IMPORTANT SAFETY RECALL

NHTSA Recall Number: 26V409
Altec Identifier: CSN-3335

Incorrect Pole Rack Capacity Value

Figure 1 — Placard Installation

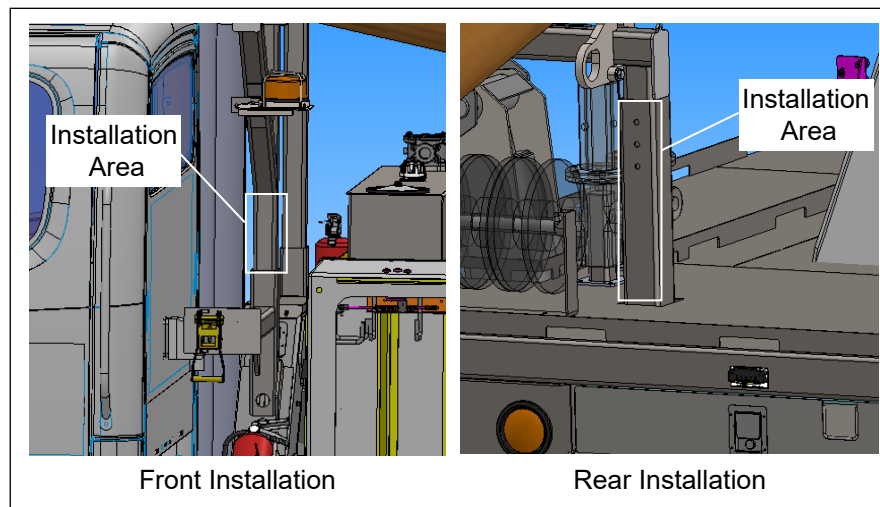
Background: Altec has learned that the vehicle pole rack load weight capacity was not calculated to the Altec standard and the listed capacity may not be correct. This can cause an unintentional overload of the pole rack assembly, resulting in a high vehicle center of gravity which could then cause a loss of vehicle control or unintended movement such as a vehicle crash, increasing the risk of death or serious injury. To address this issue, Altec has included 2 capacity placards with this notice with the correct capacity values.

Customer Action: Immediately install the 2 pole rack capacity placards included in this notice using the Installation Procedure beginning on page 2.

4. Use a water-based cleanser to clean the installation areas and allow it to dry (refer to Figure 1).
5. Install the new capacity placards in the installation areas so they are visible to the operator (refer to Figure 1).
6. Put the unit back into service.
7. Complete the Inspection and Repair sheet at the end of this notice, and return it to Altec. If the work was performed by Altec, mark this notice as complete on the Service Request.
